Access Compliance Report

Public Rights-of-Way

Intersection ID: 48556	Main Street: COTTON_PRESS_RD	Cross Street: BRANCHWATER_AV	Location: NW
ADA ID: 9F8DD0035663	Ramp Type: Perp	Initial Pass/Fail: Fail	Overall Compliance: No
Severity Score: 12.5			
Codes/Mitigation Info/Possible Solution		Field Measurements/Component Compliance

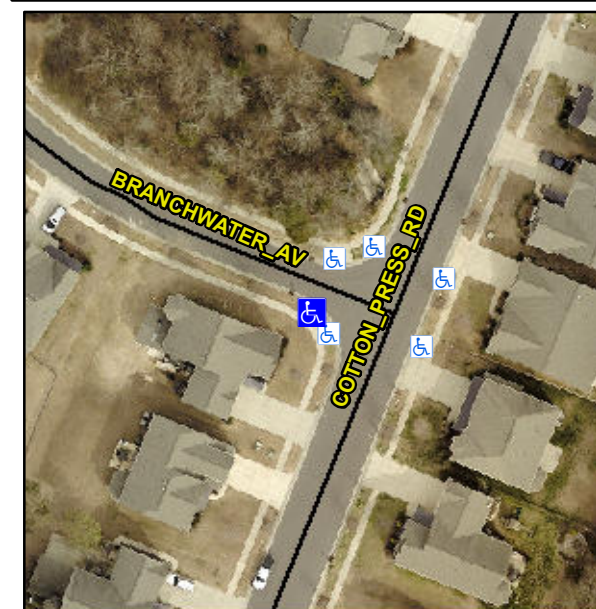
Not Found, R304.5.3

Compliance	Description	Data	Compliance	Description	Data
N/A	Ramp Length (in)	72.0	Yes	Ramp Slope (%)	5.6
Yes	Ramp Width (in)	48.0	No	Ramp XSlope (%)	5.2
N/A	Flare Type LT	N/A	N/A	Flare Type RT	N/A
N/A	Flare Slope LT (%)	N/A	N/A	Flare Slope RT (%)	N/A
N/A	Flare Traversable LT?	N/A	N/A	Flare Traversable RT?	N/A
N/A	Landing Length (in)	N/A	N/A	DWS Provided?	N/A
N/A	Landing Width (in)	N/A	N/A	DWS Contrast?	N/A
N/A	Landing Slope (%)	N/A	N/A	DWS Length (in)	N/A
N/A	Landing X Slope (%)	N/A	N/A	DWS Full Width?	N/A
N/A	Landing Curb? (Y/N)	N/A	N/A	DWS Offset (in)	N/A
N/A	Shared Landing?	N/A			
N/A	Gutter Ponding?	N/A	N/A	Gutter Slope (%)	N/A
N/A	Gutter Lip Ht (in)	N/A	N/A	Gutter X Slope (%)	N/A
N/A	Painted X Walk1?	No	N/A	Painted X Walk2?	N/A
	X Walk 1 Direction	To NE		X Walk 2 Direction	N/A
N/A	X Walk 1 Width (in)	N/A	N/A	X Walk 2 Width (in)	N/A
	X Walk 1 Slope (%)	2.5		X Walk 2 Slope (%)	N/A
	X Walk 1 X Slope (%)	3.4		X Walk 2 X Slope (%)	N/A

Remove & Replace Entire Ramp.
